File No: 17-020
 Project Name: Aspen Meadows Phase II
 Description: Public Hearing and Preliminary Site Plan Approval
 Date of Agenda that packet pertains to: March 1, 2018

Project: Aspen Meadows II

Re: Aspen Meadows Phase II Preliminary Site Plan Review – 3rd Review

Subject: 17-020: Aspen Meadows II Planned Development
Preliminary Site Plan Review #3

Preliminary Site Plan - Phase II
"ASPEN MEADOWS II SITE CONDOMINIUM"
 WHITE LAKE TOWNSHIP, OAKLAND COUNTY, MICHIGAN

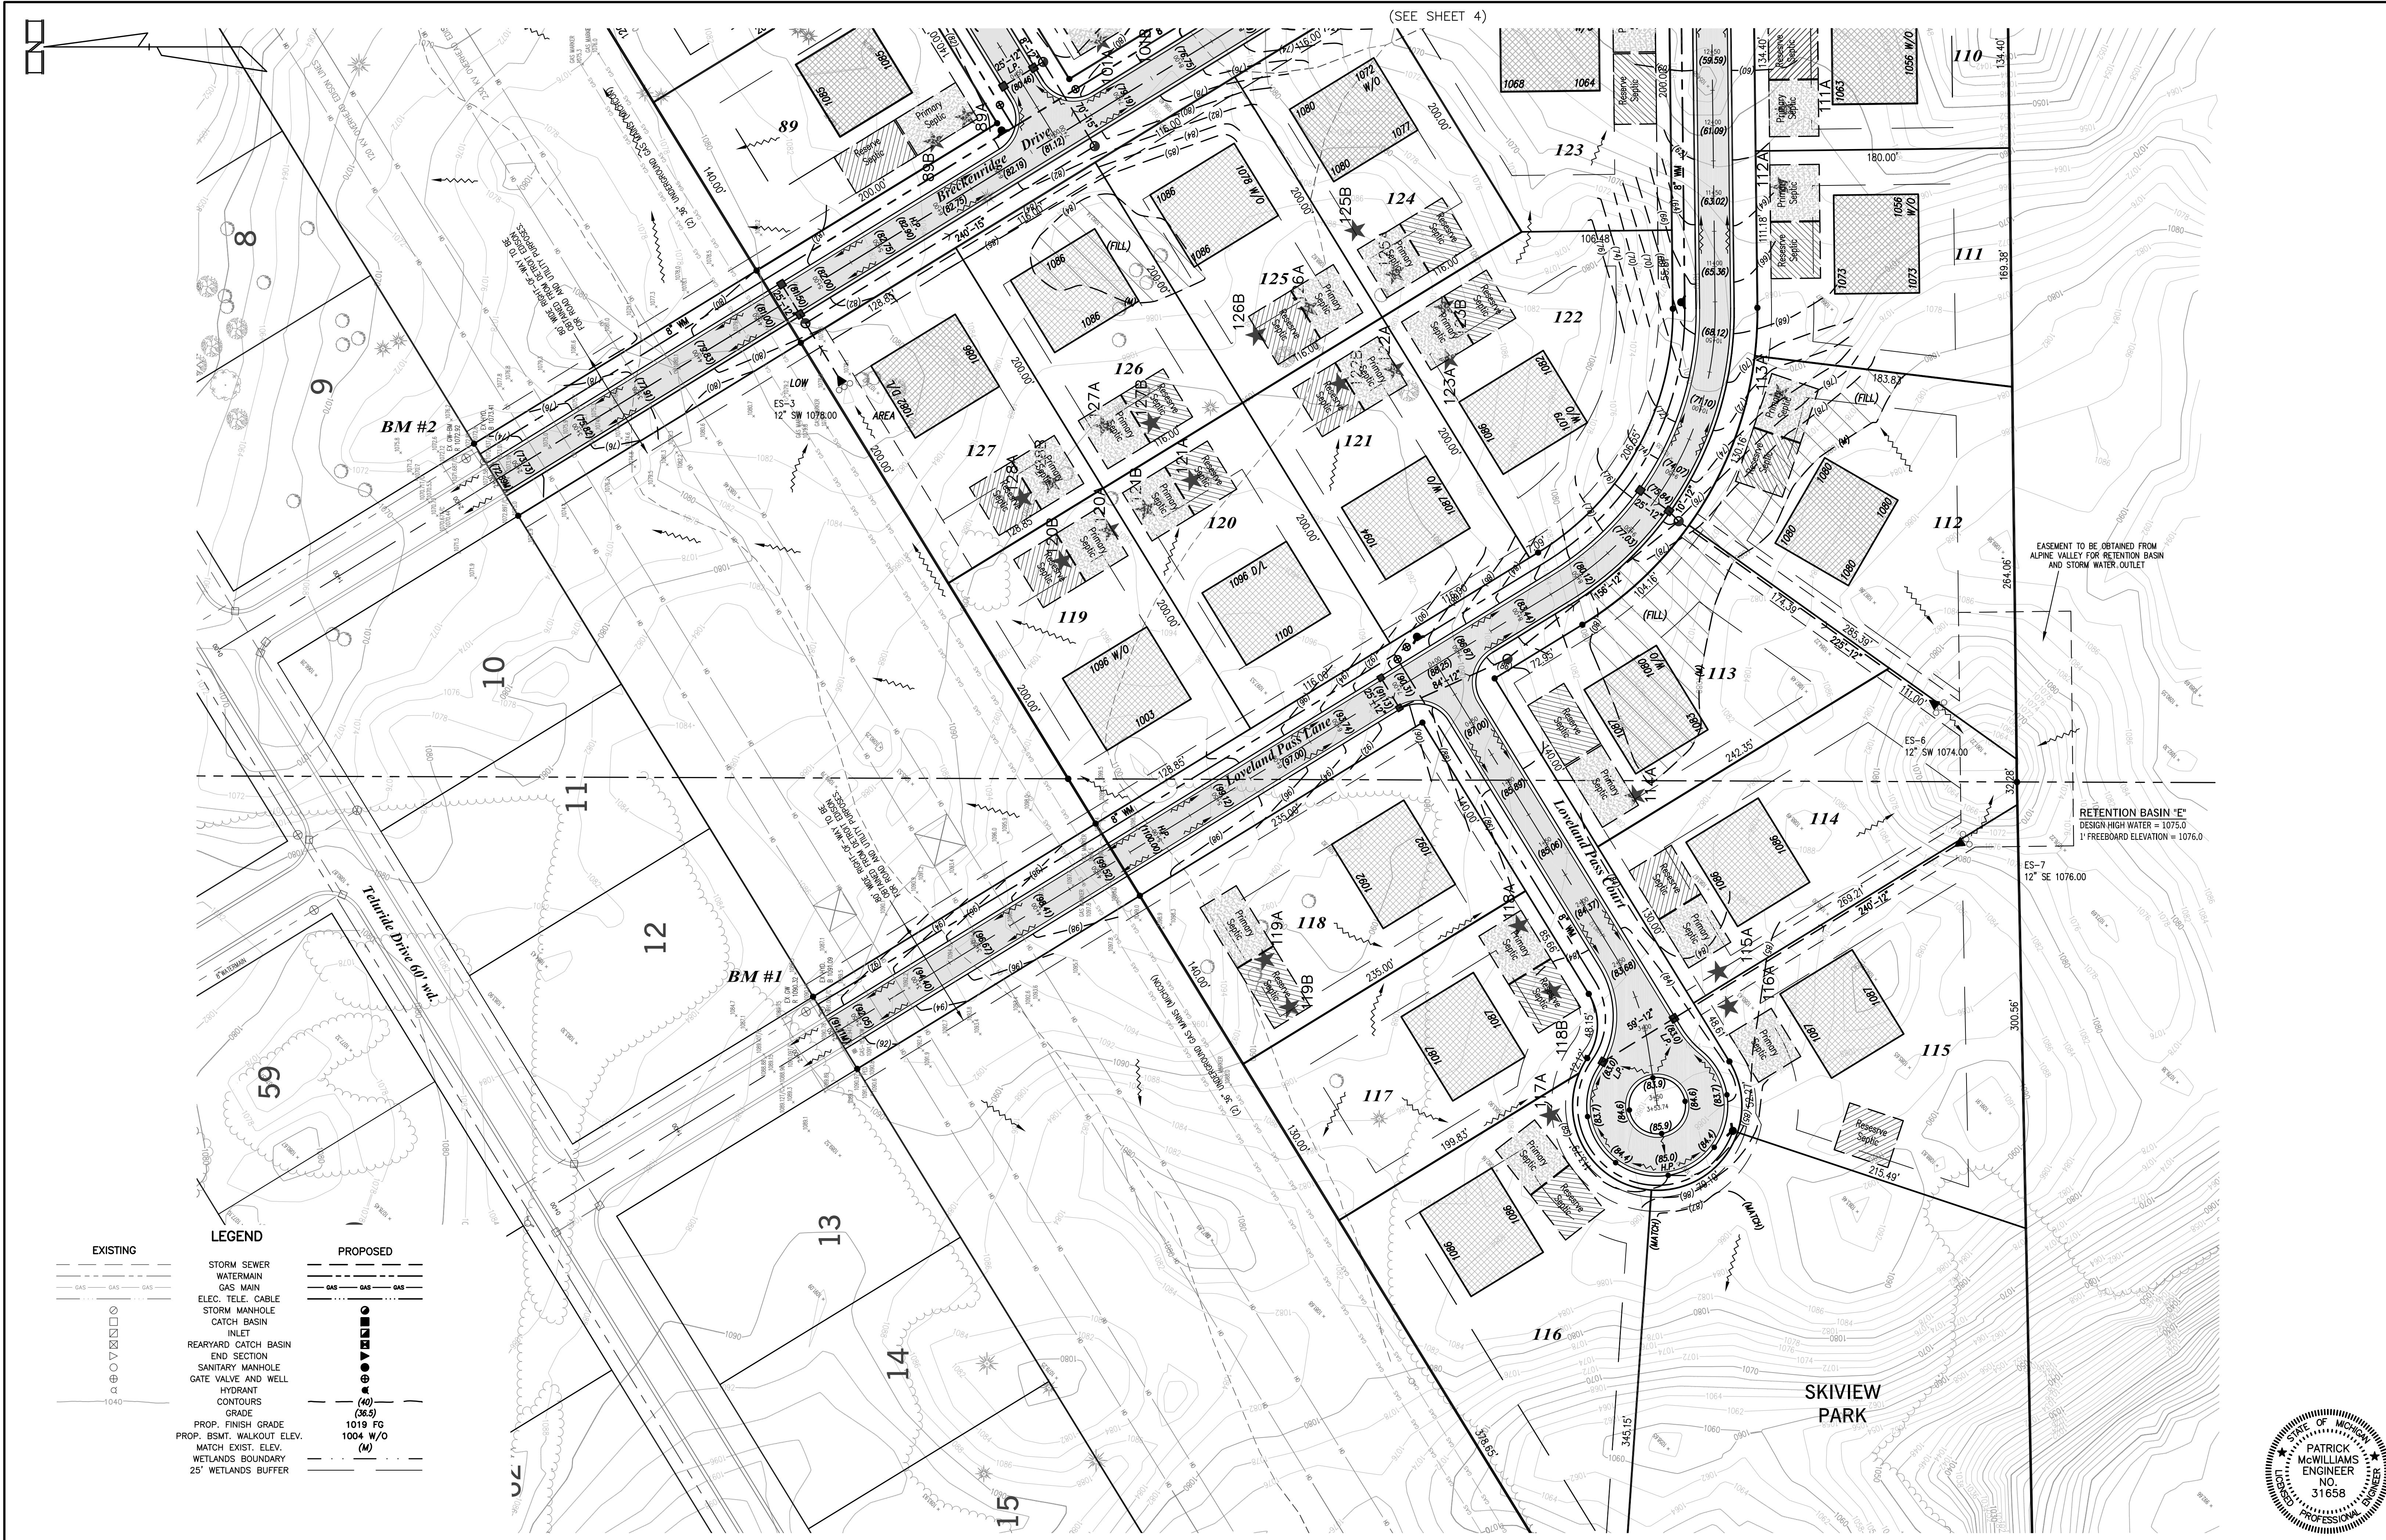
1. *The tributary area to all basins and size in acres must be shown on the plan. (The plans have been modified to show the drainage district areas. We have a concern with large drainage areas shown discharging offsite. The plans show 1.54 acres discharging to the south, 5.6 acres discharging to the east, 4.7 acres draining to the south west. Clarification will be required regarding these discharges, every effort must be made to direct storm water from onsite areas to the onsite detention facilities. The detention basins will also need to be resized to accommodate this additional water.) (The Applicant met with J&A and the Township Planning staff to review the intent for the stormwater management system in an effort to come to an understanding in regards to the challenges of the stormwater management system for this site. The applicant has placed 40 to 50 foot natural buffers along the east property line in an attempt to minimize any impact from the development on properties to the east. The applicant has also provided calculations on the plan that indicate proposed post development runoff to adjacent property will be less than what currently exists based on agricultural runoff coefficients.)*

2. *Clarification will be required regarding the proposed pond outlets and the ultimate destination for this discharge. Offsite easements will be required for the storm water point discharges. (Comment remains, White Lake Township Engineering Design Standards dictate (C.1.a.) "When concentrated storm water is proposed to be discharged over, onto or across private property other than that owned by the developer, an agreement between the owners must be executed relieving the Township of any responsibility for damage that might occur." We recommend the offsite discharge routes be defined and an easement be required over the drainage course to the point of ultimate discharge. If an agreement with the*

adjacent property owners is not possible, retention may be required.) (Detention basin C has been revised to now be a retention basin which eliminates the need for an agreement with properties to the east. The applicant has indicated they intend to pursue an agreement with the property owner to the south for stormwater discharge from detention basin D. The applicant has better demonstrated the natural drainage course this discharge is intended to take. Provided the applicant can secure an agreement with the south property owner we believe the applicant has met the intent of the stormwater detention standards for this level of submittal.)

TYPICAL ROAD SECTION
NOT TO SCALE

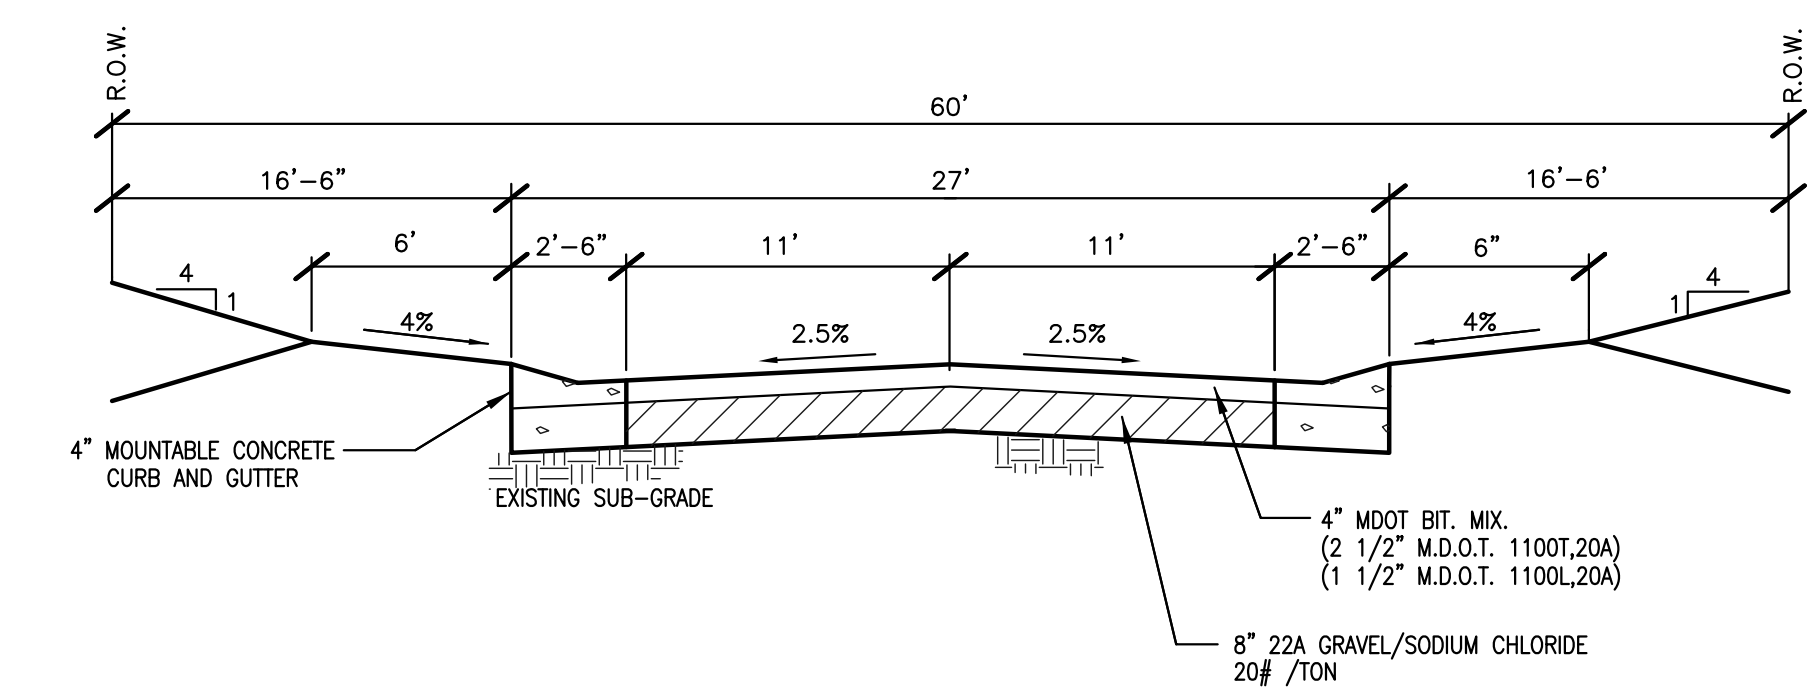
6. **Sidewalks and Non-Motorized Pathway:** Section 6.7(C)(i) recommends sidewalks along all frontage streets and sidewalk connections to all major rights-of-way. The typical road cross-section provided does not provide for sidewalks along the proposed streets, but sidewalks are now shown in plan view. It does not appear that the first phase of Aspen Meadows had sidewalks.
